DEPARTMENT OF THE NAVY
USS SPERRY (AS-12)
APO SAN FRANCISCO 96601

From: Commanding Officer, USS SPERRY (AS 12)
To: Nuclear Regulatory Commission
SUBJECT SECTION
Subj: Quality Assurance for Packaging of Radioactive Material
Ref: (a) Nuclear Regulatory Commission ltr FCTR:RHO 71-0265
of 5 Jul 79
(b) SPERRYINST 9900.4
Encl: (1) Changes to SPERRYINST 9900.4

Organizational Structure

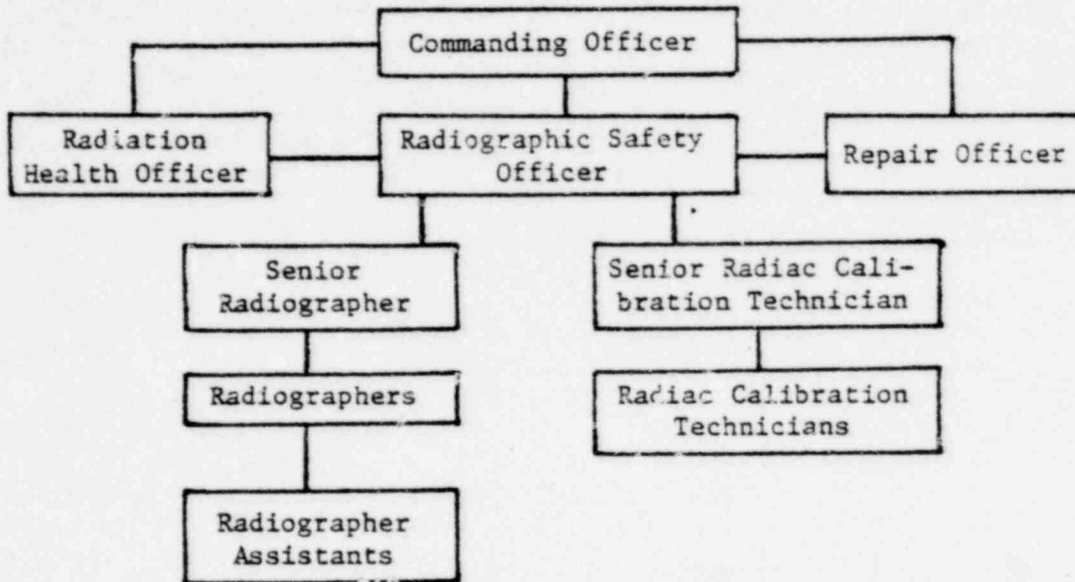
e. Replace reference (b), enclosure (1), with "Organizational Structure" in enclosure (1).

1. The Chain of Command aboard USS SPERRY (AS-12) for utilization of sealed sources for Radiography and Radiac Calibration is as follows:

2. The Chain of Command aboard USS SPERRY (AS-12) for the custody of sealed sources is as follows:
